I received addendum No. # 02 on October 20, 2025 for 4823 Johnson County BRO-R051(41) Bridge Replacement Project

This addendum involves 4 pages including this sheet.

> 10/20/2025 JOB 4823

> > S2

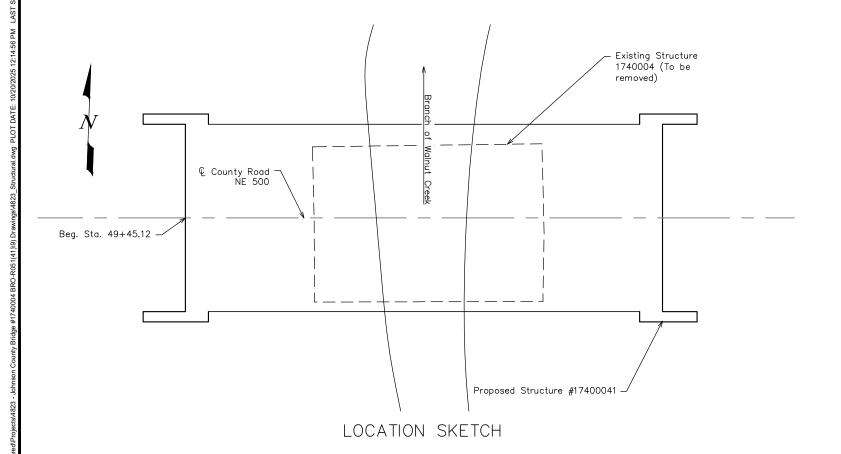
ltem		Substr.	Superstr.	Tota
Class 1 Excavation	cu. yard	60		60
Removal of Bridges	lump sum			1
Galvanized Structural Steel Piles (12 in.)	linear foot	200		20
Pre-Boring for Piling	linear foot	80		81
Pre-Boring for Piling Pile Point Reinforcement	each	8		
Class B Concrete (Substructure)	cu. yard	21.9		21.
Slab on Concrete Beam	sq. yard		166	16
Bridge Guardrail (Thrie Beam)	linear foot		150	15
27 inch Prestressed Concrete Spread Box Beam	linear foot	178		17
Bridge Approach Slab (Minor)	sq. yard		109	10
Plain Neoprene Bearing Pad	each		6	6
Vertical Drain at End Bents	each		2	2

Pre-bore for piles at Bent 2 to elevation 690.79. A minimum of 5 feet of prebore into rock shall also be obtained.

> > S7

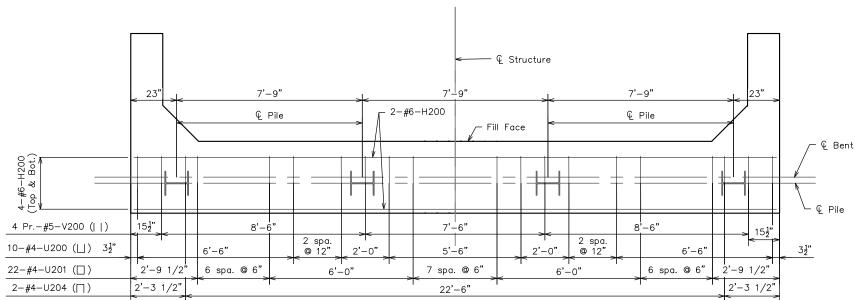
Substructure Quantity Table for Be	nt No. 2	
	Item		Quantity
	Class 1 Excavation	cu. yard	30
	Galvanized Structural Steel Piles (12 in.)	lin. foot	80
$\mathbb{A}\{$	Pre-Boring for Piling	lin. foot	80
	Pile Point Reinforcement	each	4
	Class B Concrete (Substructure)	cu. yard	10.8
